Re: Appendix to Unionville Sub-Committee Meeting February 15, 2023

On February 15 2023, Capital Works Engineering staff provided a presentation titled “Main Street Unionville Revitalization Project”. The presentation provided an update on the road, boulevard, sidewalk and border pavers.

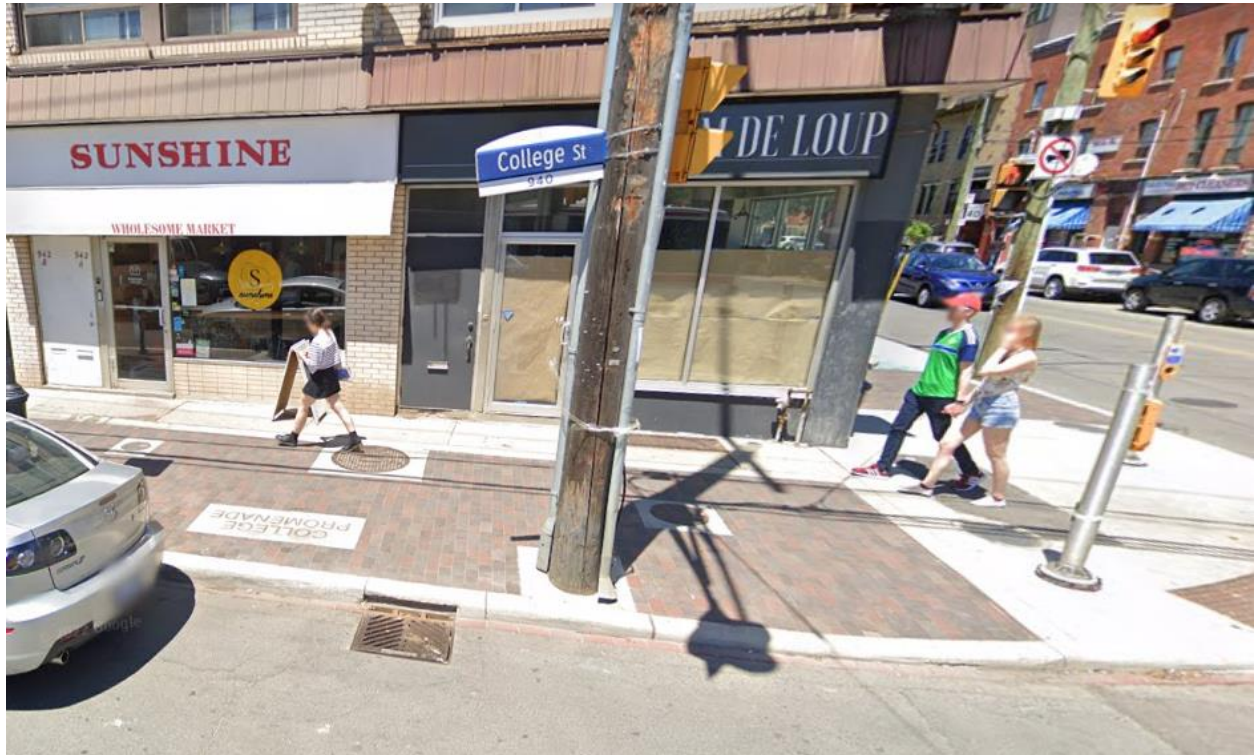
Question 2:

The consultants rationale for recommending the five colours of pavers be used for the road pavers.

The design Consultant, CIMA+, included five colours for the mockup of the road to show all the colour options available, and is similar to the example that was referenced on College Street (installed about 5 years ago). See photo of the location below.

Upon further review, the comparison below shows that there is not a significant difference to the appearance from a 5 colour brick combination to a 3 colour combination.
